Inspection Report Type: Fire-resistant Penetrations and Joints

DOB Application #: M00864036
 Address: 1717 Broadway
 Job Name: Granite 1717 Hotel

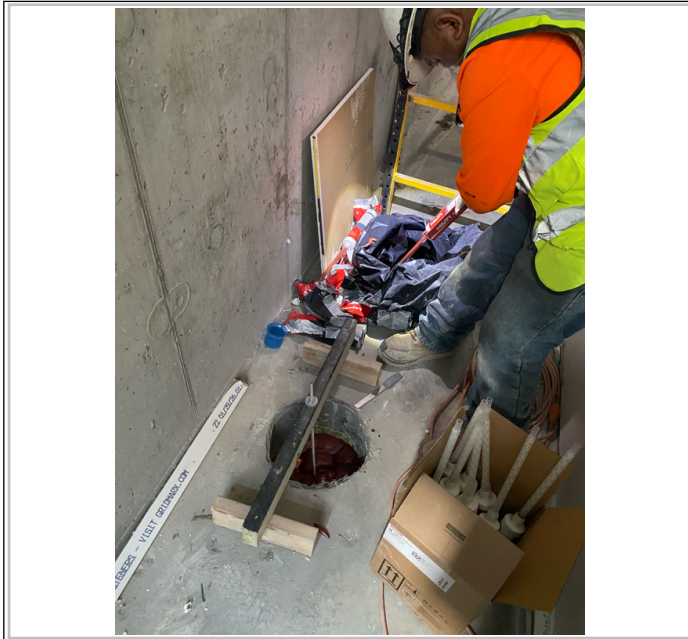
Description: Per ASTM E2174 Section 11 Reporting and section 7 Inspection Documents
- Socotec reviewed the MGE submittal and no tested systems applied to today's firestop. Socotec notified the contractor of the missing documentation.
- the Hilti catalog was checked for CP620 tested systems and none could be found at time of inspection
- The firestop is not approved until an EJ or tested system can be submitted
- The firestop detail will need to be reviewed before final signoff of this type of installation

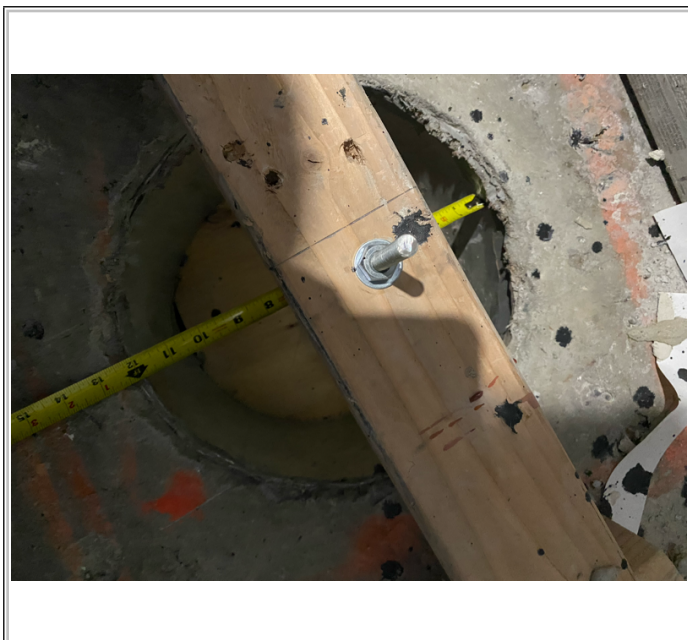
Per the installation instructions, the oil in the beginning tube is discarded before application. The contractor filled 3 holes full depth.

Hilti CP620 was used however, the material is tested for penetrating items, not for blank openings. The EJ is required.

12" diameter area of circle is 113 sq inches

9.5 inch depth of concrete
